TOWN OF MONUMENT 2.0 MG WATER STORAGE TANK

2.0M GALLON TANK
SITE GRADING PLAN

Site Development Plan _V2.pdf Markup Summary 1-18-2022

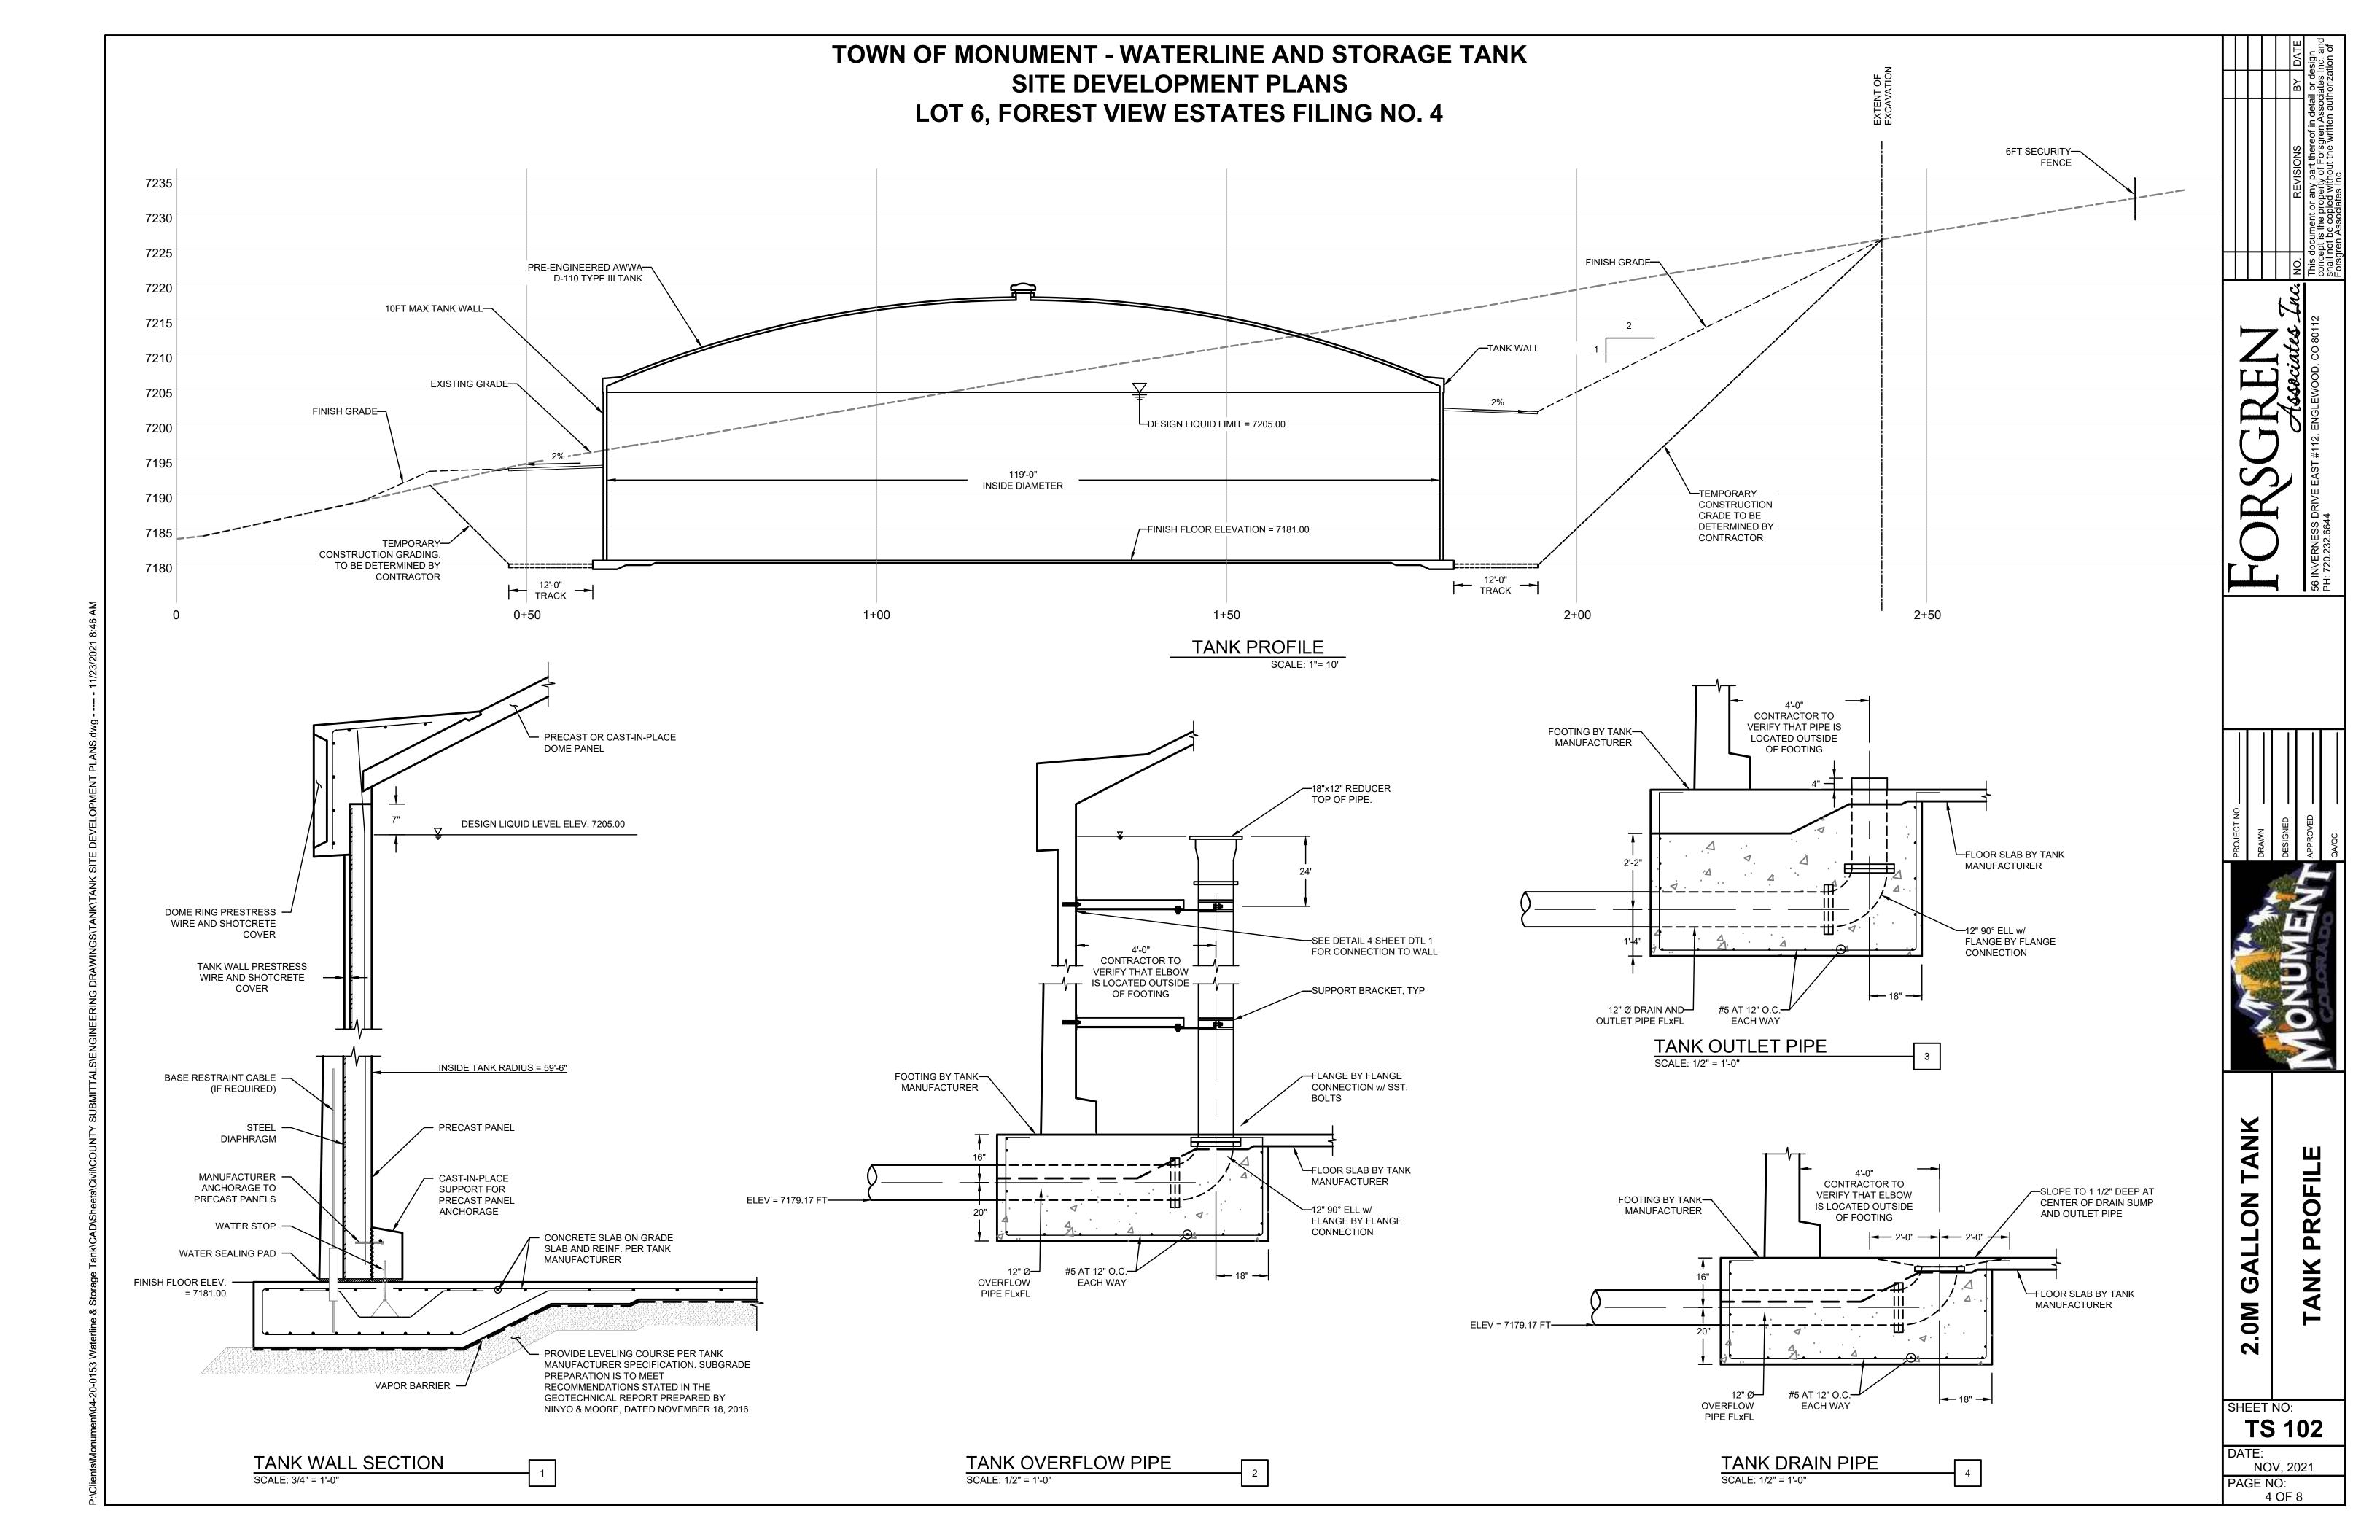
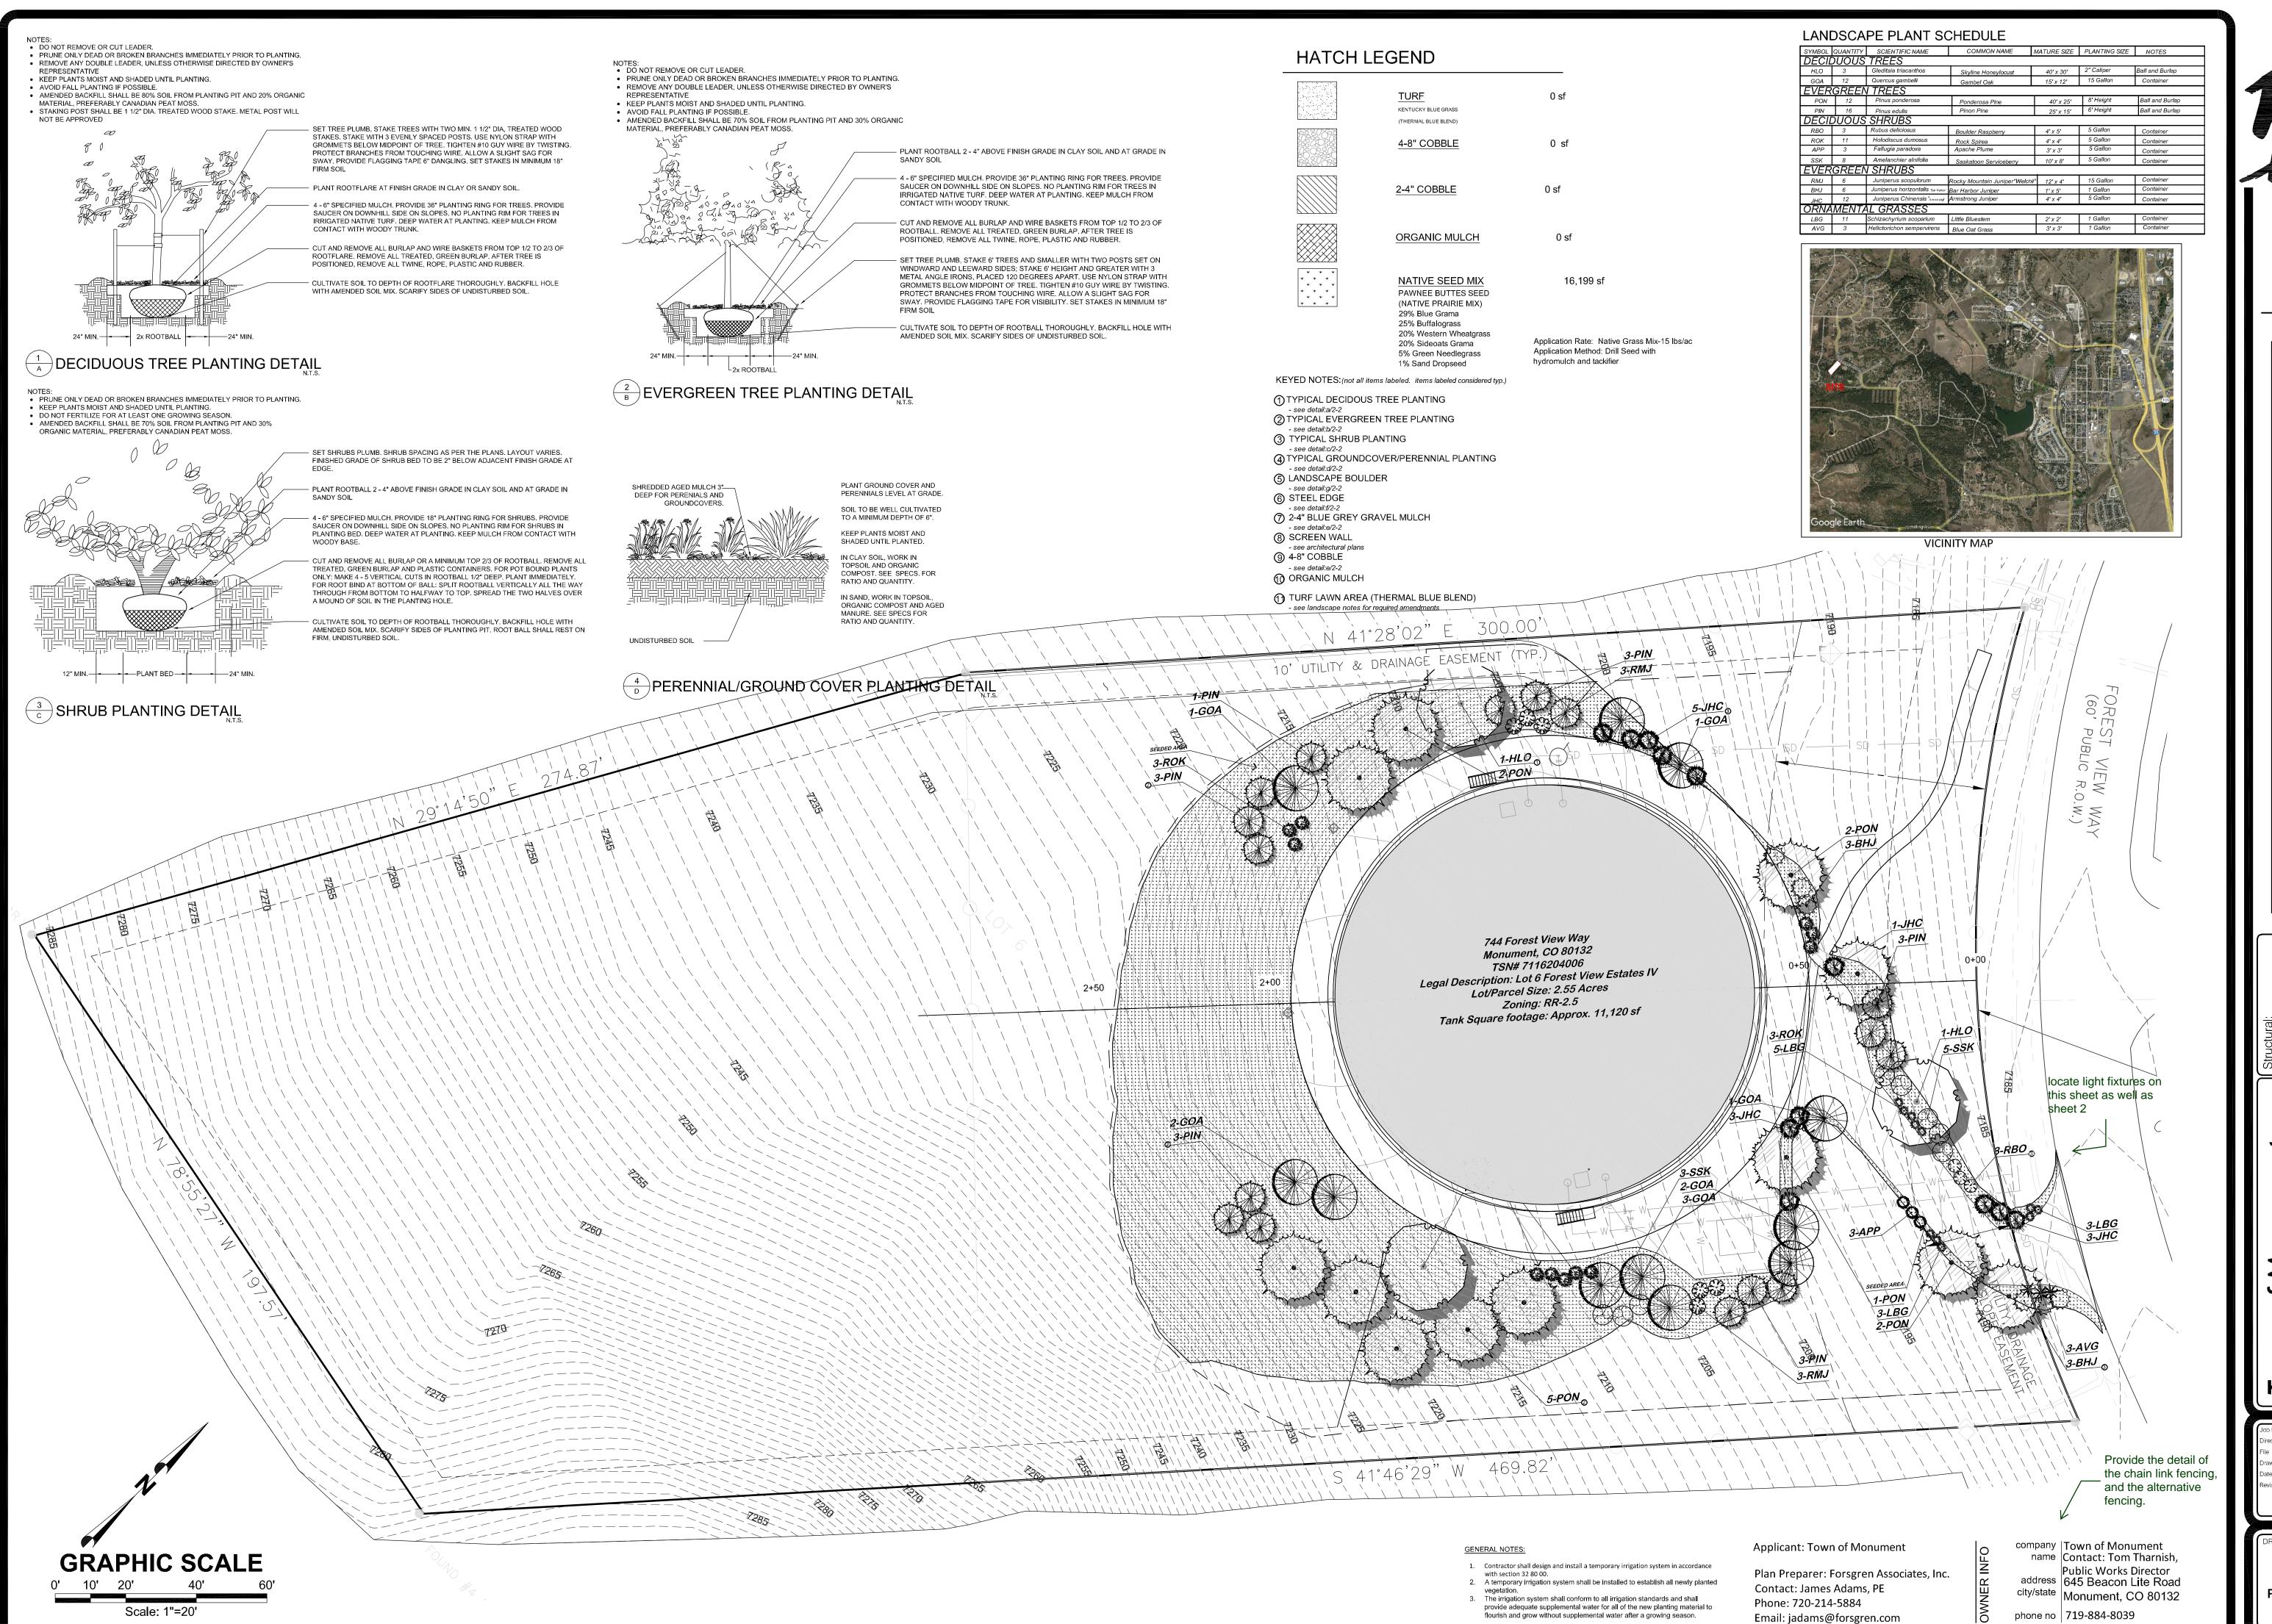
delete this from al;l pages- this is for a construction approval REVISIONS BY copied without the written authorization of Associates Inc.

Add dimensions of chlorine bldg and future landing

Add circumference and total gallon storage

delete this from al;I pages- this is for a

T of 1
FINAL LANDSCAPE

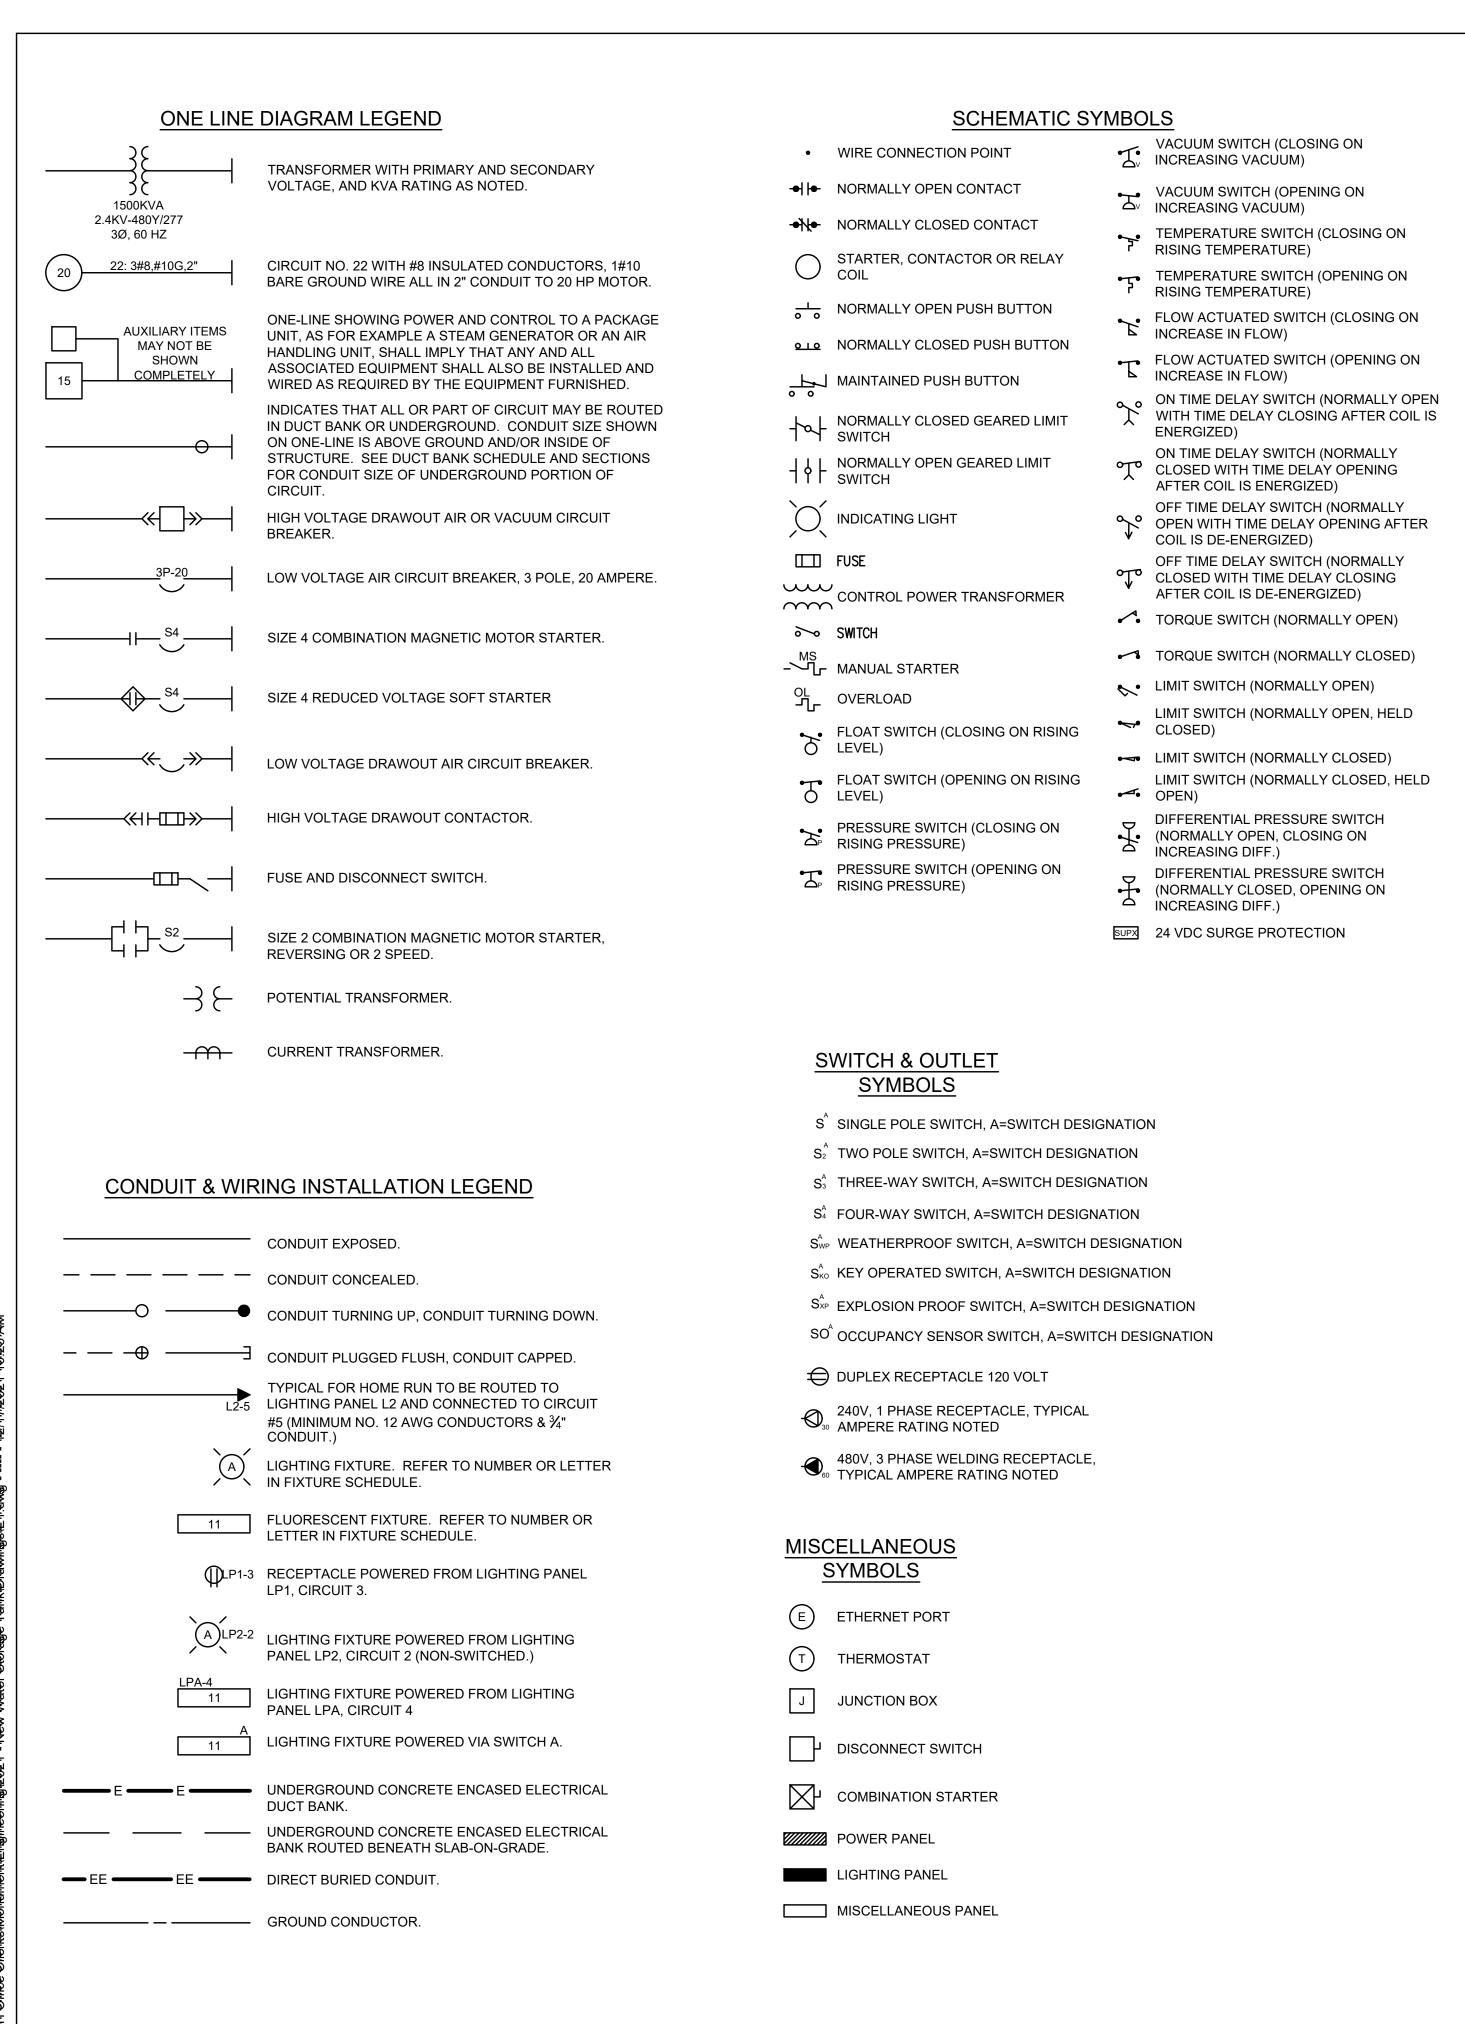
locate light fixtures on this sheet as well as sheet 2

Provide the detail of the chain link fencing, and the alternative fencing.
